GOLD DUST APARTMENTS

Preliminary Drainage Report

April 17, 2023

DRB RE-SUBMITTAL 04/17/2023

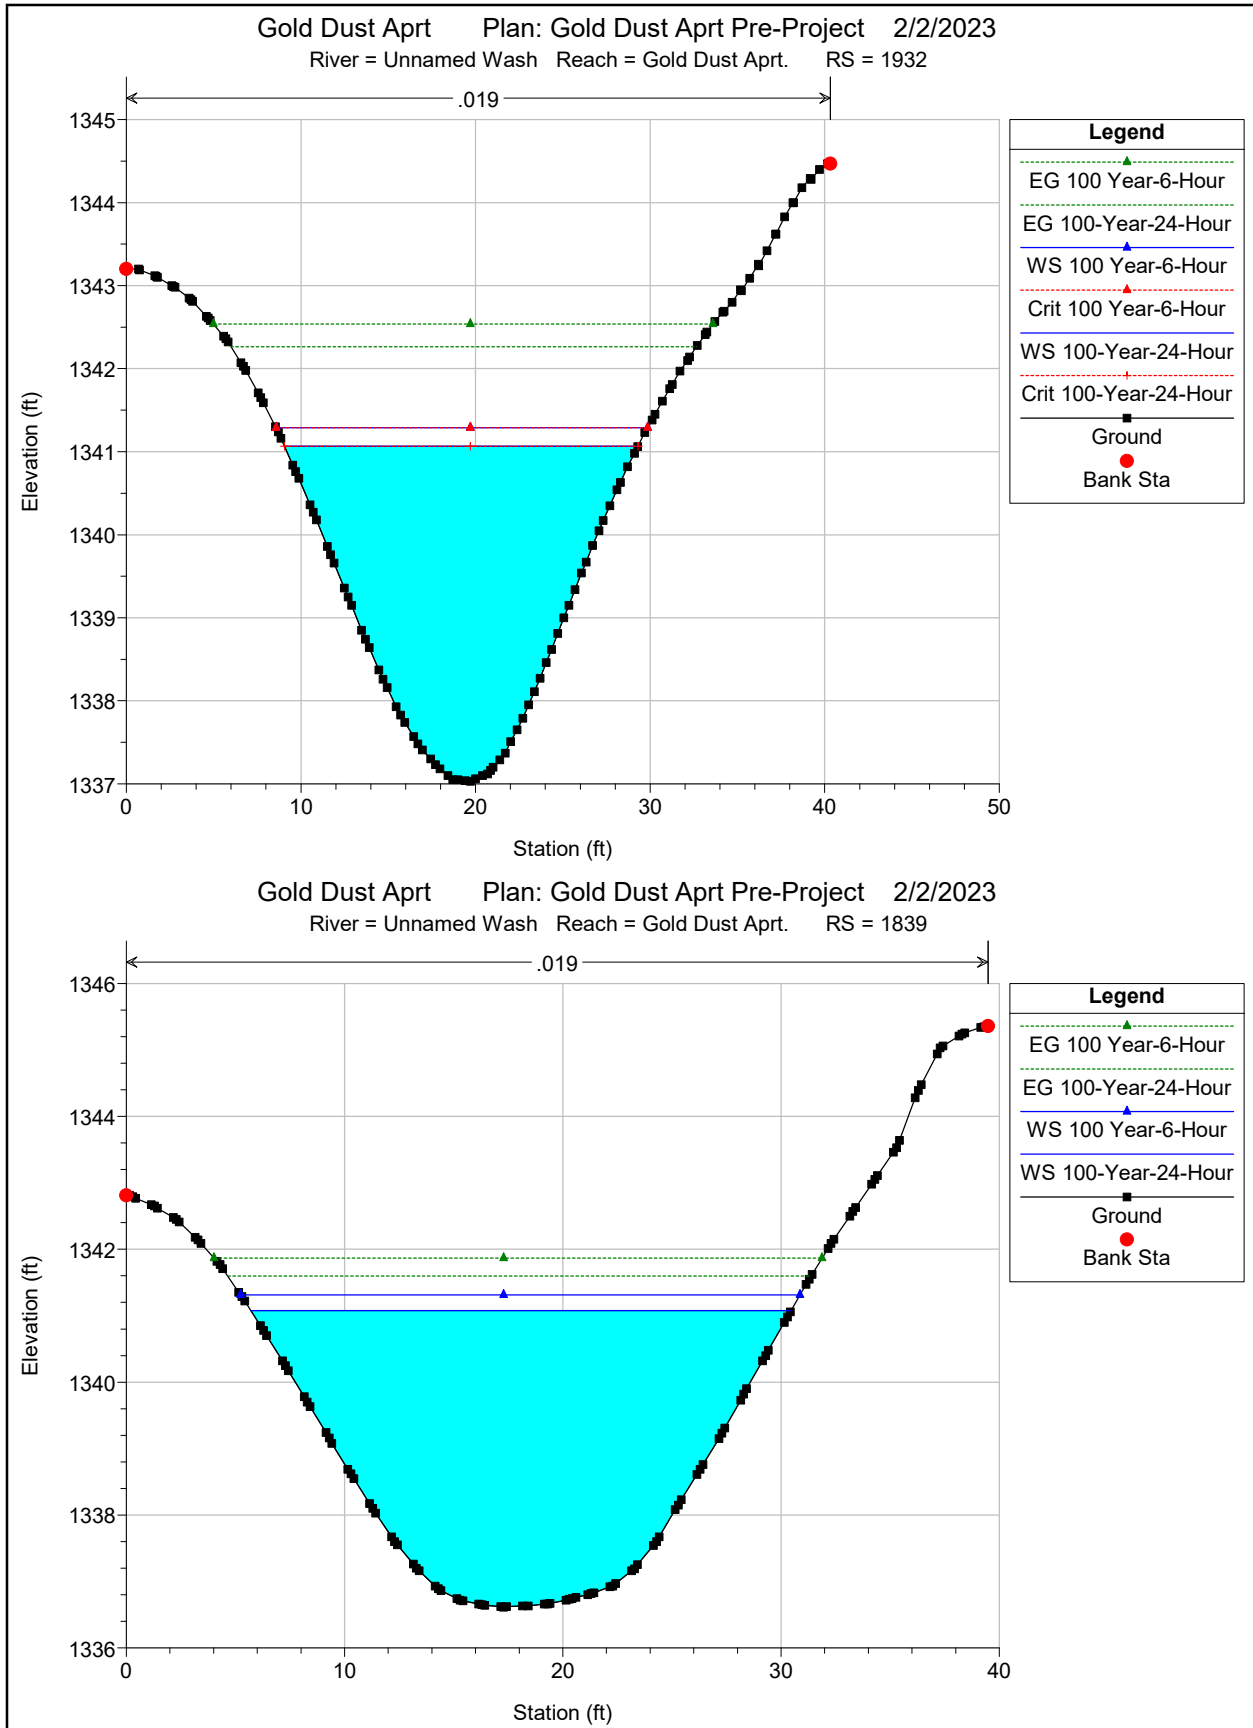
The n-value of 0.019 is not mentioned in the report. Where did it come from? Also, all bank stations are at the limits of the cross sections, please revise in final plans. (typ for all HEC-RAS)
